ADDENDUM

Project: Huntsville 1,2, South Fork	Project No.: 502184719020101	Addendum No.: 2
Project Address: 277 South 7400 East, Huntsville, Utah		Date: June 6, 2019
Owner: Corporation of the Presiding Bishop of The Chur of Latter-day Saints, a Utah corporation sole From (Architect): <u>McNeil Engineering</u>	rch of Jesus Christ	
Instructions to Prospective Bidders:		
This Addendum forms a part of the Contract Documents and modifies the original Bidding Documents and/or prior Addenda as noted be

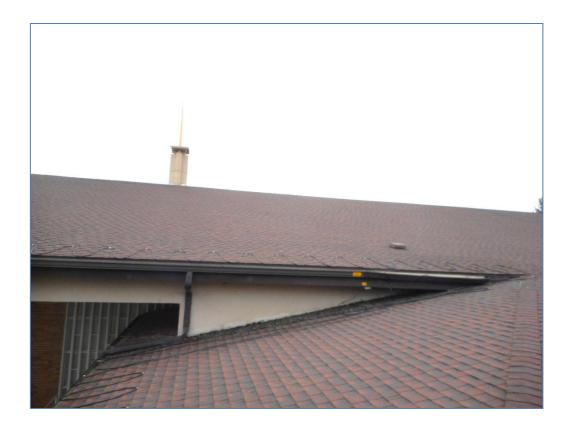
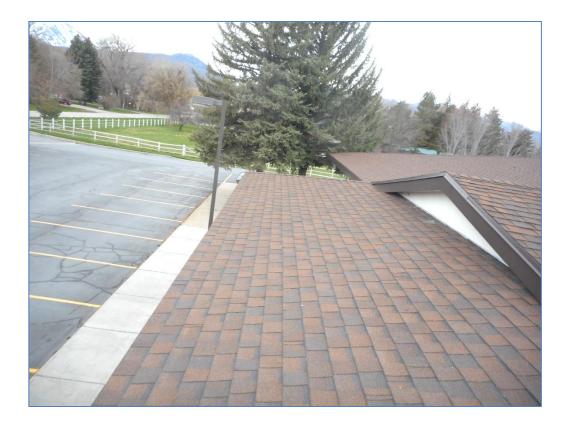
- 5. Changes to Drawings:
 - a. All blocking at the eaves of the roof are to have three (3) 3" holes drilled in each truss bay block. The holes shall be equally spaced acrossed each block. If the truss spacing is less than 24" O.C. the engineer will give the hole size and spacing needed for what spacing is being worked with. Plastic baffles shall be installed in each truss bay to hold the insulation away from the ventilation slot. The baffle vent slot is to be a minimum of 2" deep from truss to truss.

- b. The stucco on the side wall locations on the north and south sides of the chapel roof as well as the small gable end area on the Relief Society addition shall be removed and replaced with new stucco and wall flashings. All labor, materials, accessories needed to complete the work shal be part of this contract. See attached photos for locations. The stucco on the beams is to be included with this work. The stucco on the east and west gable ends is not part of this work. Also the stucco above the east entryways is not included in this work. If there is no insulation installed under the original stucco the contractor will not apply any insulation to the new system. The specification for the EFIS system is attached.
